BRAIDWOOD CONSTRUCTION ASSESSMENT PROGRAM (BCAP)

MONTHLY BRIEFING

REGIONAL OFFICE -- REGION III
U. S. NUCLEAR REGULATORY COMMISSION

N. N. KAUSHAL
BCAP DIRECTOR
DECEMBER 6, 1984

CSR WELD MAP

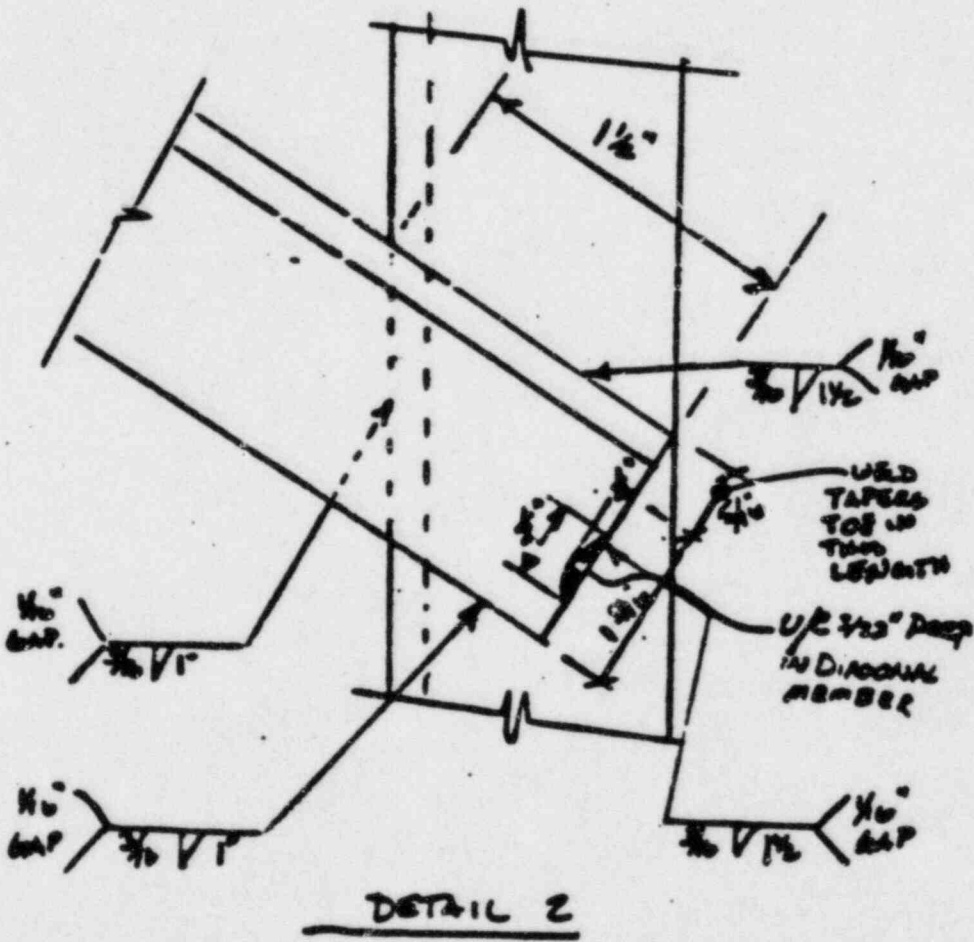
WELD DISCREPANCIES ON HVAC SUPPORTS

LINEAR INDICATION IN
HVAC DUCT TO STIFFENER WELDS

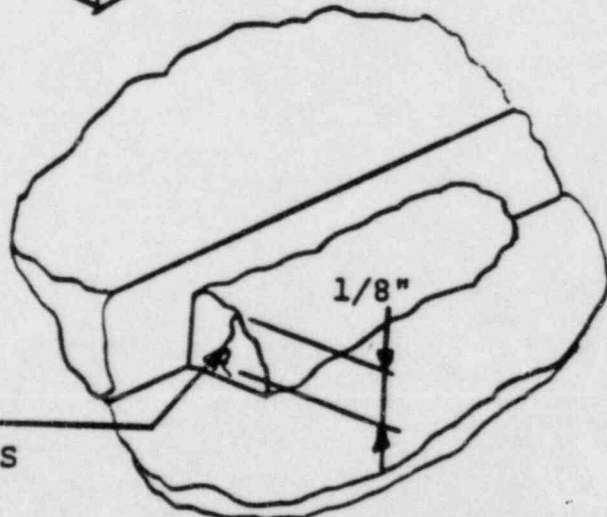
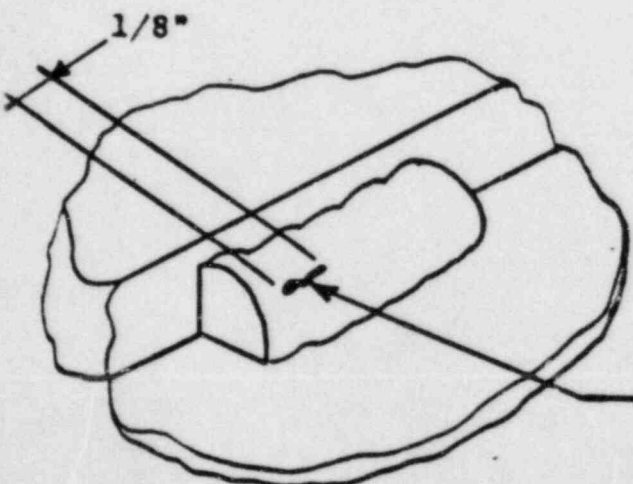
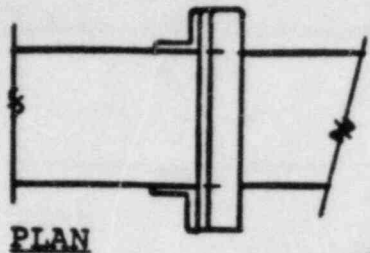
LINEAR INDICATIONS
